**Project: BALL FIELDS FOAM PADDING
AND VINYL COVER REPLACEMENT SERVICES**

RE: Addendum #1

(Ball Fields Photographs)

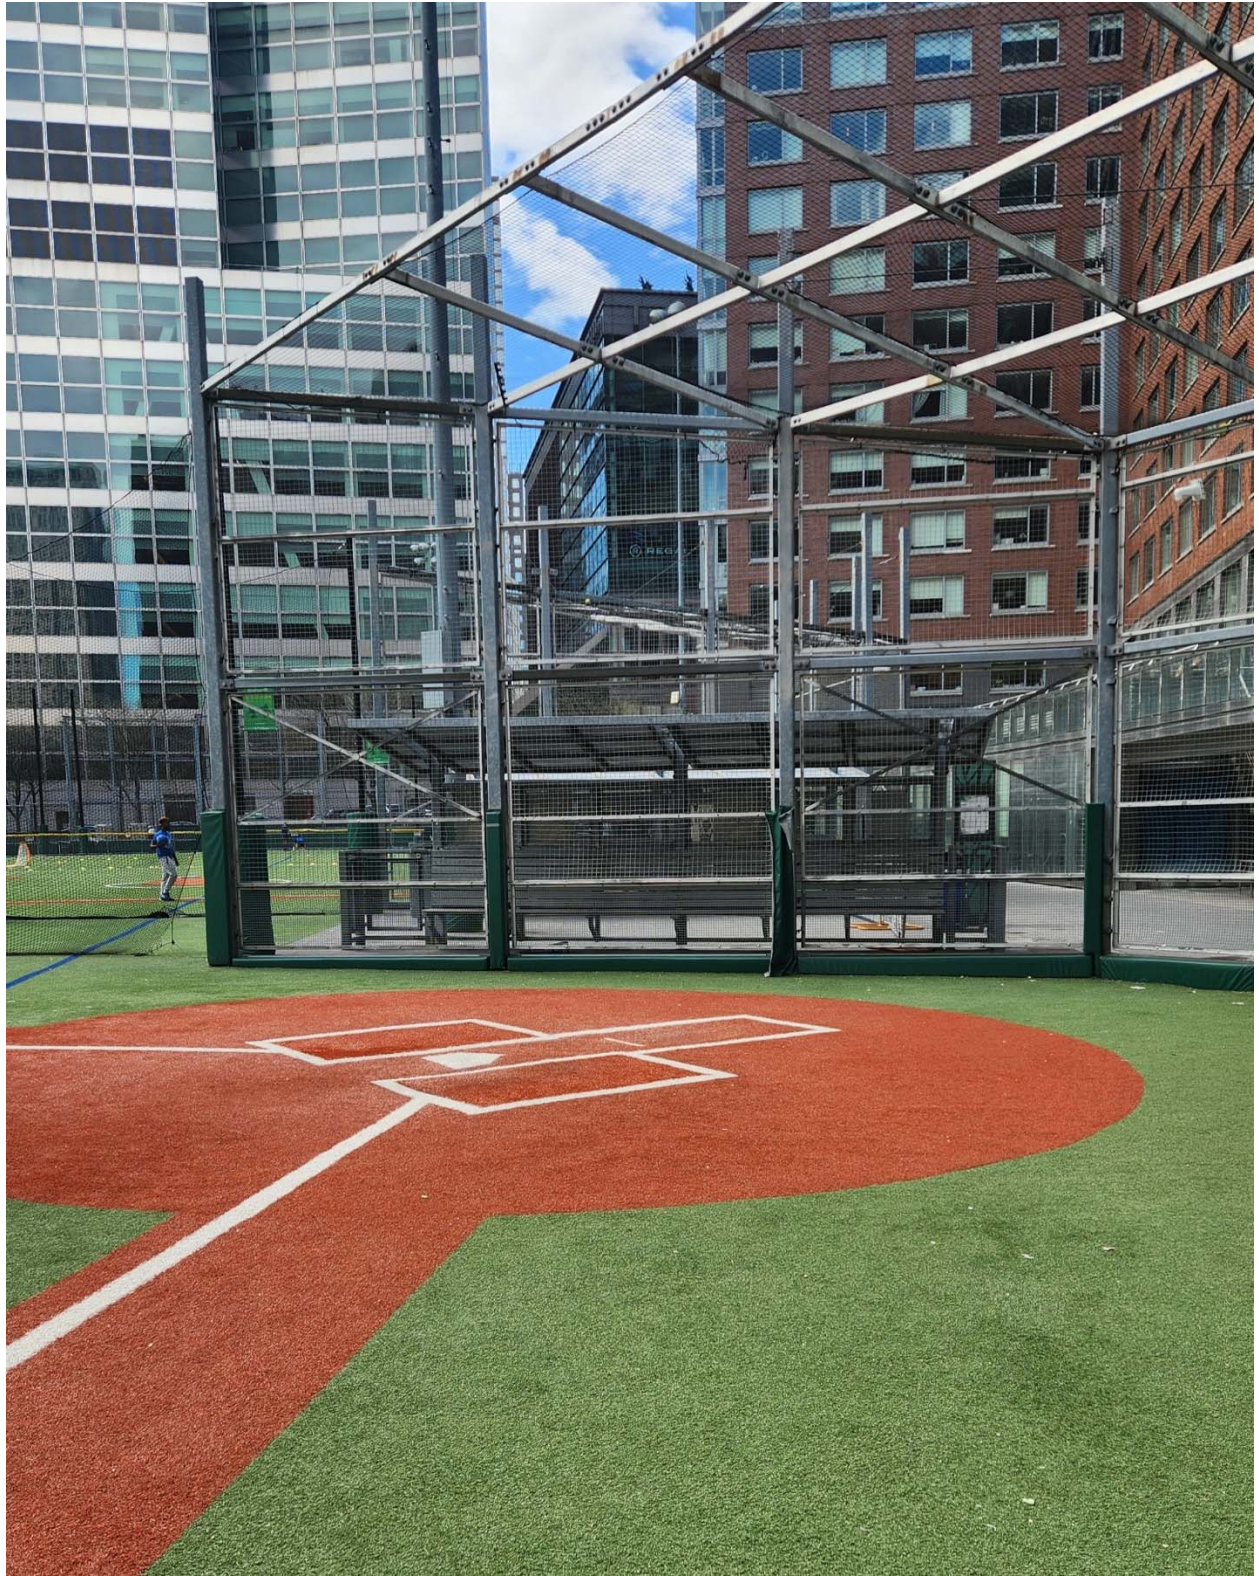
1. Do you have photographs of the existing padding?

Yes, please see attached Exhibit A: Ball Fields Photographs.

EXHIBIT B

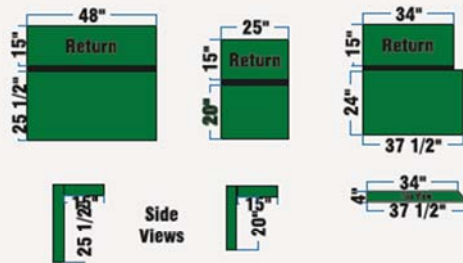
2. Do you have any drawings of the field or any supporting drawings/images you can provide?

Attached as Exhibit B is a drawing utilized in connection with the last padding replacement project. Its inclusion here is not a representation as to its accuracy, or as to the acceptability of the product identified therein. The selected proposer has an obligation to confirm all dimensions prior to procuring the padding and provide its own set of submittals.
